GOFFSTOWN RAIL TRAIL CONSTRUCTION PROJECT

**ADDENDUM 2**

TOWN OF GOFFSTOWN, NEW HAMPSHIRE			
BICYCLE - PEDESTRIAN RAIL-TRAIL			
ADDENDUM NO. 2		04/23/2015	
No.	Revision	Date	Appvd.
<b>General Plan &amp; Profile</b>			
<b>Site 1</b>			
DATE	VHB PROJECT NO.	DRAWING	STATE PROJECT NO.
DECEMBER 18, 2014	52168	52168-GEN	16029
SHEET NO.	TOTAL SHEETS		
8	34

NHDOT STANDARD PLANS	REV. DATE		PLATE
	HEADWALLS FOR R.C. PIPE:	CONCRETE	06-16-2010
	MORTAR RUBBLE MASONRY		STANDARD
			HW-2

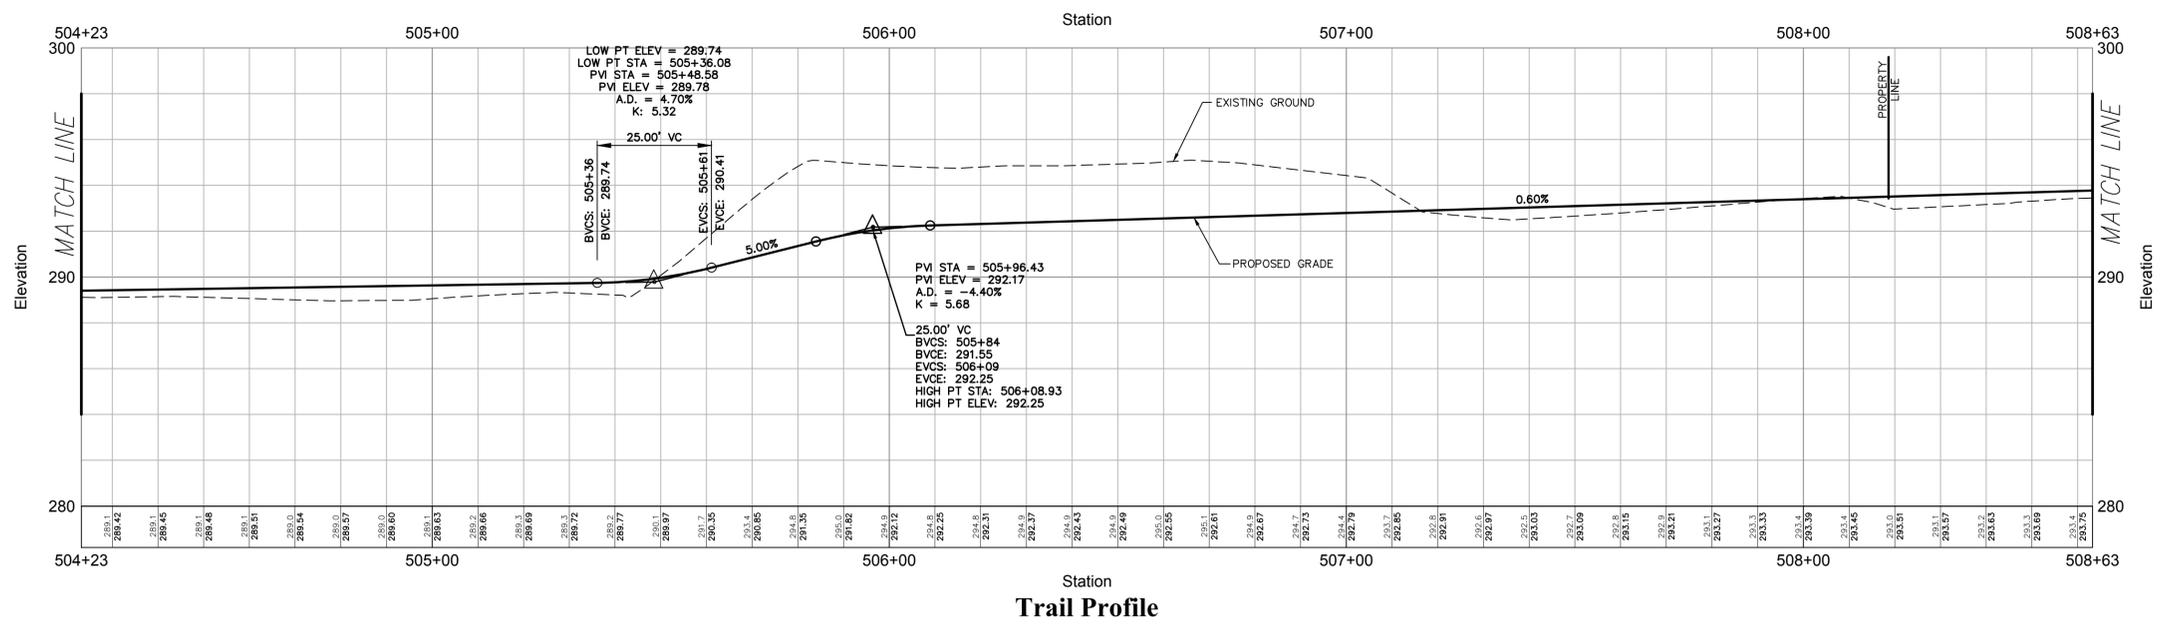
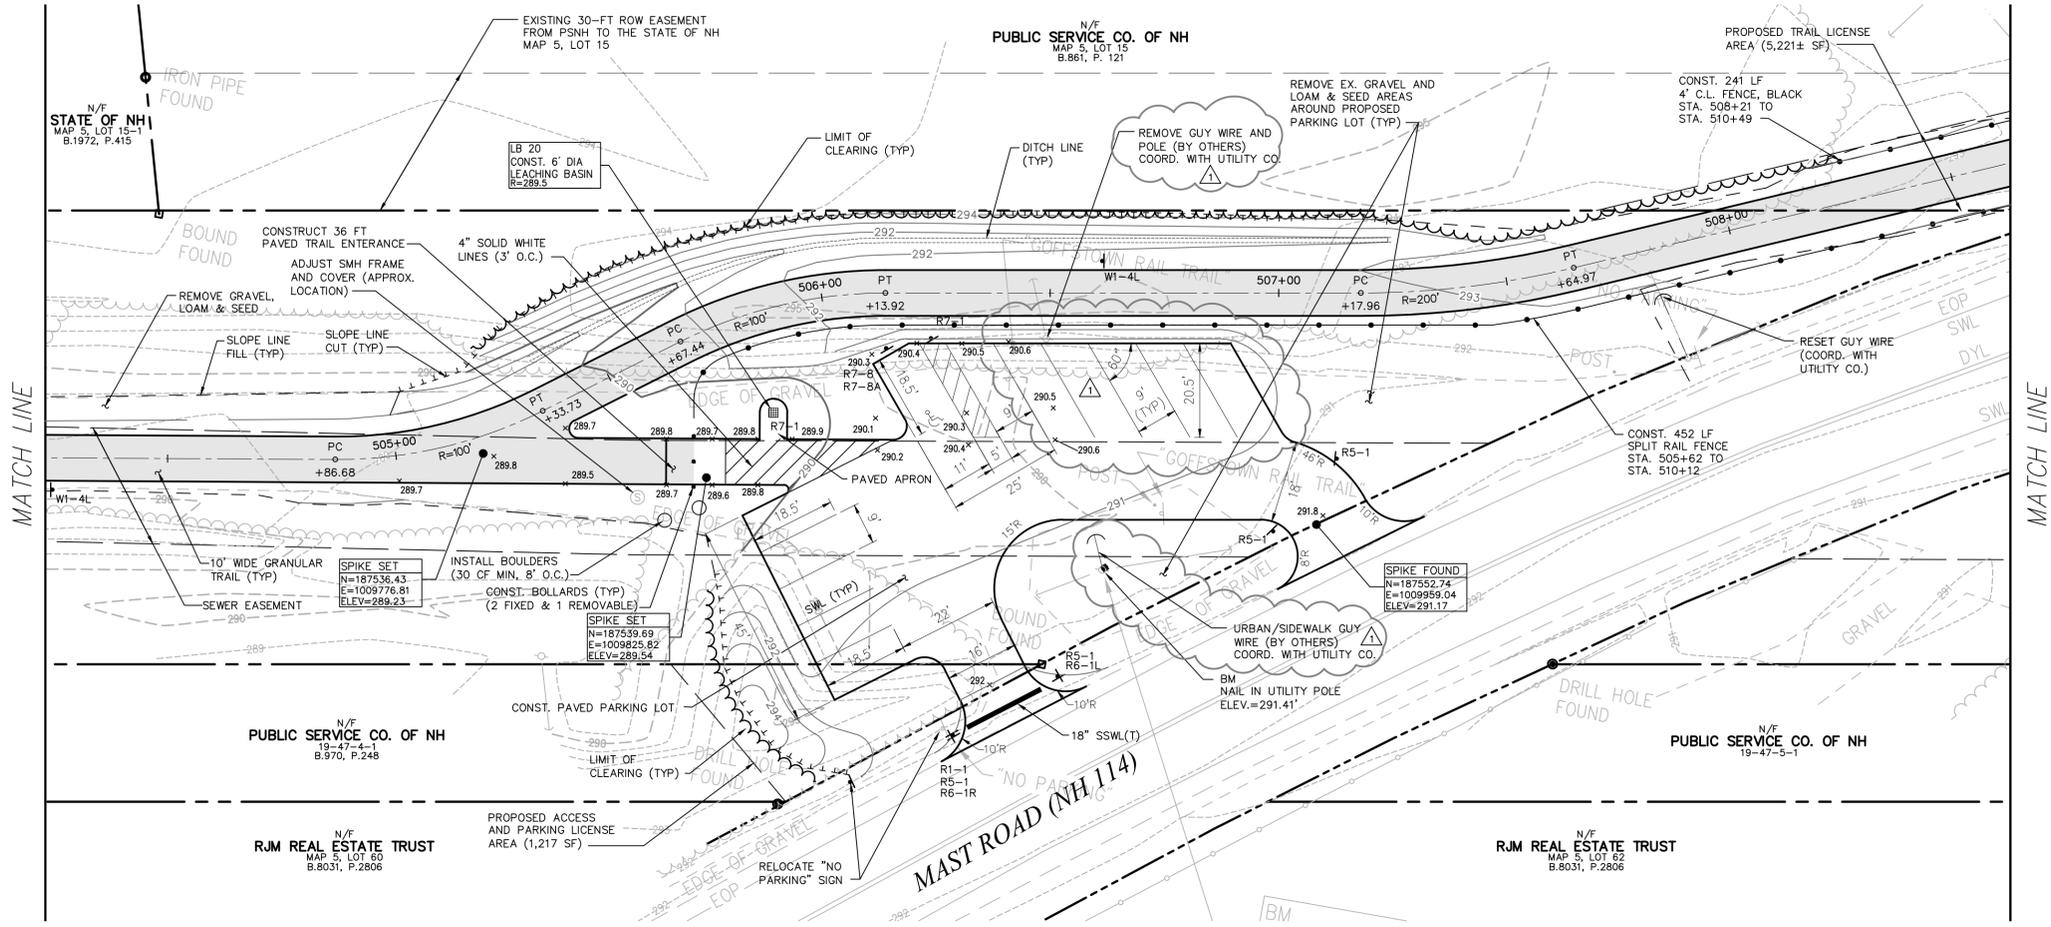
**3.0 CONCRETE HEADWALL FOR 18" R.C. PIPE:**

The concrete headwall detail on Plan Sheet 5 shall be replaced by NHDOT Standard Detail HW-2 – P.C.-3 as shown below:

The associated pay items for the above headwall shall be added to the Bid Form as follows:

520.10	1.32	CONCRETE CLASS A				
		AT _____				
		DOLLARS				
	CY	CUBIC YARD				
544	11	REINFORCING STEEL				
		AT _____				
		DOLLARS				
	LB	POUND

The dollar amount from the above two headwall related items shall be reflected in the Total Bid amount on page SP-9 of the Bid.

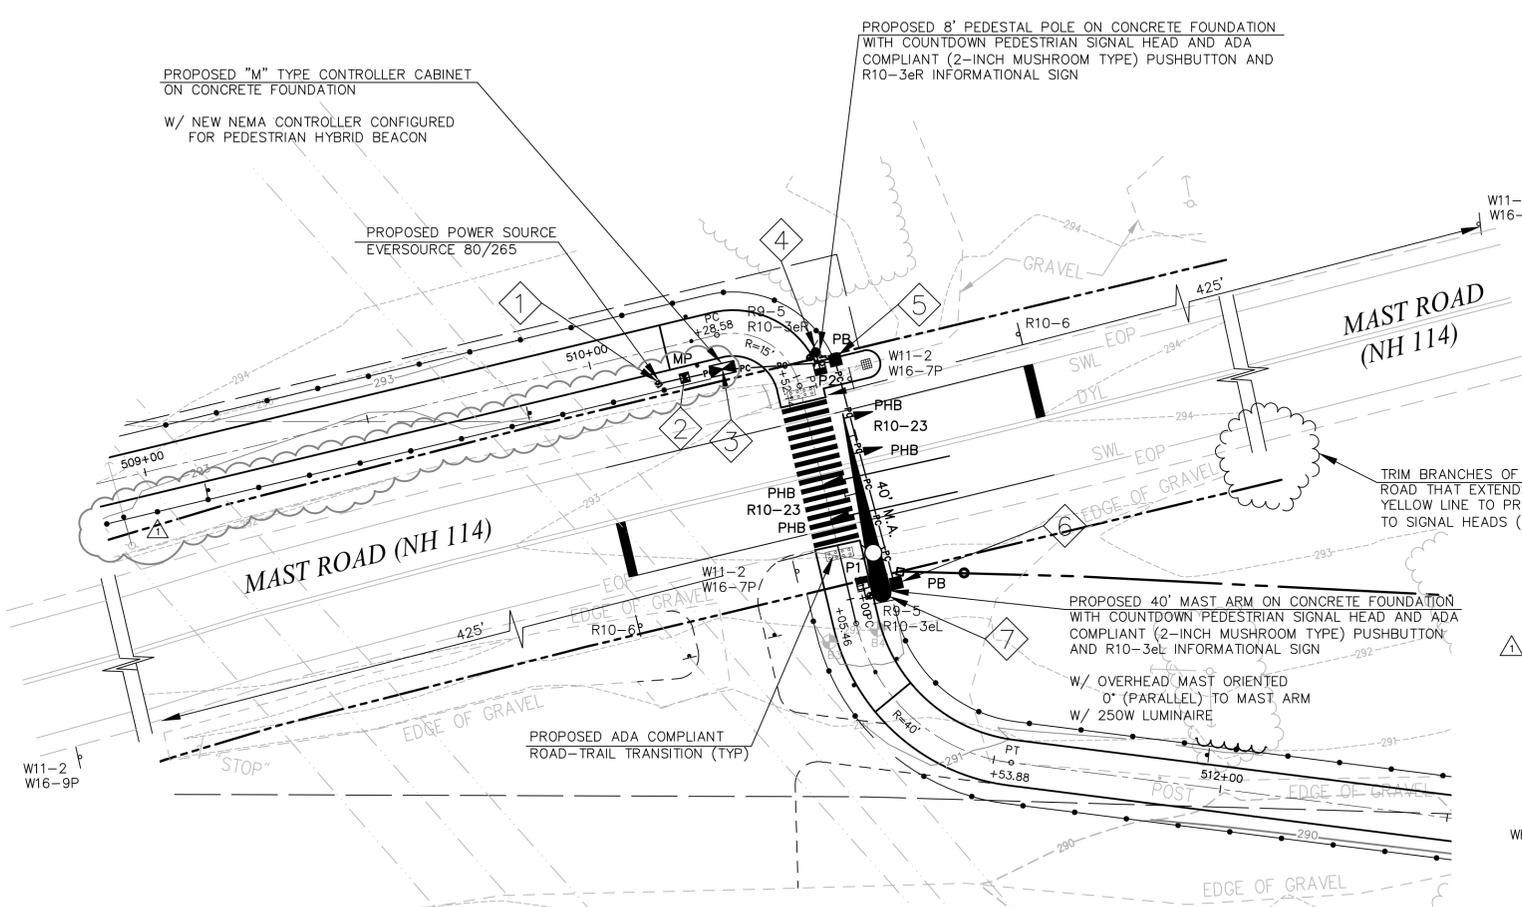
**SHEET 15 of 34:**

The power feed to the traffic signal controller will come from Eversource utility pole # 80/265 at approximate Trail Station 510+15 RT instead of from the original pole located at approximate Trail Station 508+93 RT. The quantity of 3" Schedule 40 PVC conduit under Pay Item 616.3101 is reduced by 119 linear feet to 50 linear feet. The List of Major materials in the Item 616.3101 traffic signal special provision is hereby amended accordingly.
